DEVELOPMENT REVIEW COMMITTEE (DRC) COMMENT REPORT

PROJECT NAME: Fairfield Cypress Creek

CASE NUMBER: PLN-SITE-20050005

REQUEST: Site Plan Level III Review: Conditional Use for Height, 295 Multi-Family Residential Units, 2,323 Square Feet of Retail, 6,850 Square Feet of Restaurant, 21,715 Square Feet of Office, 15,847 Square Feet of Existing Office with Shared Parking in the Uptown Project Area

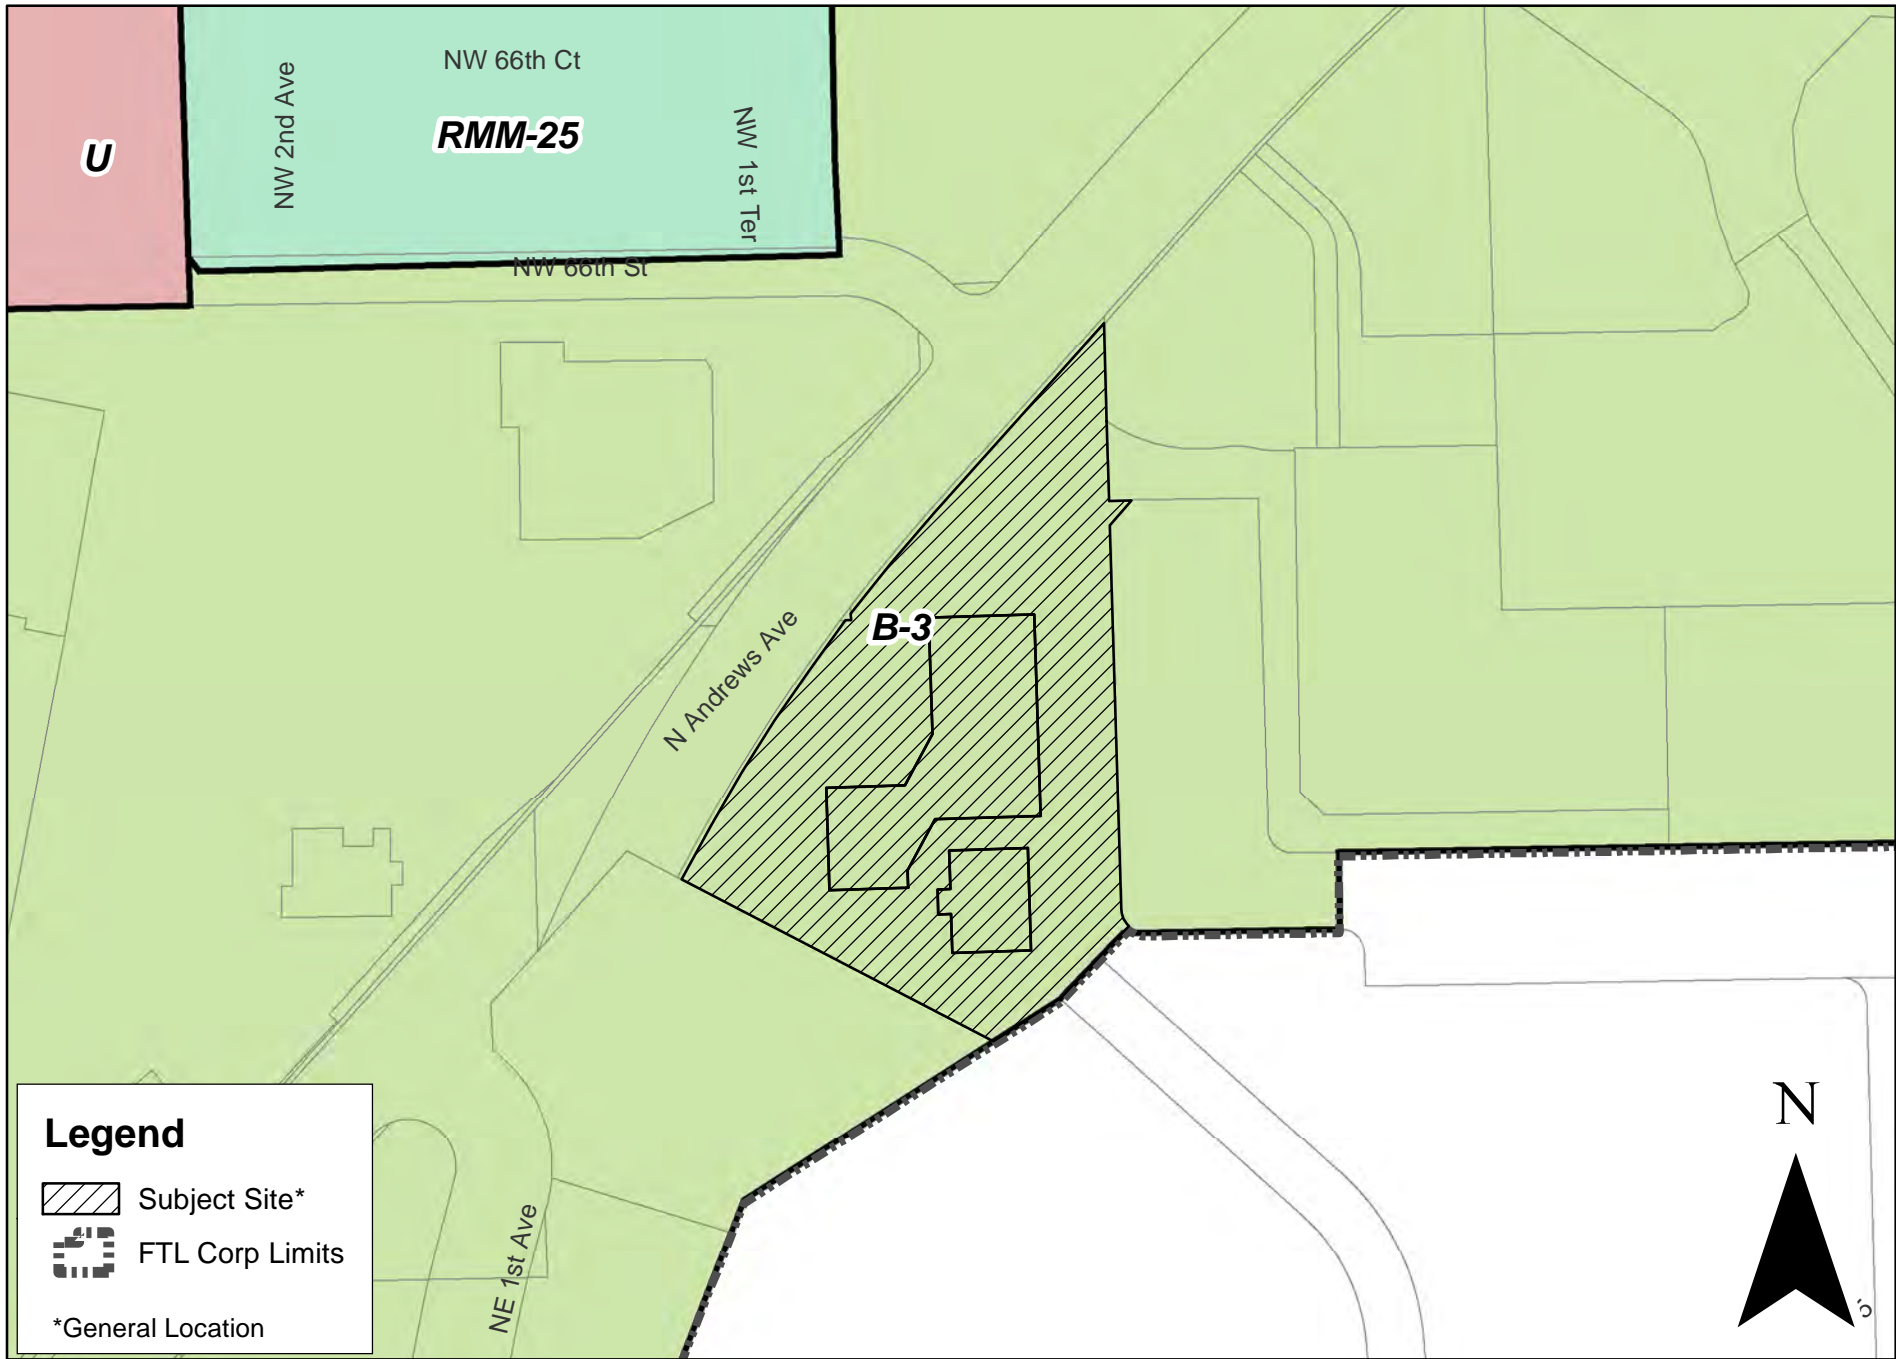
- c. Provide stronger vertical articulation along the west elevation. See image examples below;
 - d. Provide screening for the parking structure east elevation to reduce the exposure of the structure. Consider creative solutions that can be illuminated at night, somewhat similar to the Zimmerman building. See image examples below;

- e. Enhance the building design for the northwest and southwest building corners as previously stated. See image examples below; and
 - f. Provide detail imagery for building features such as stacked stone, mesh guardrail, and security fence.
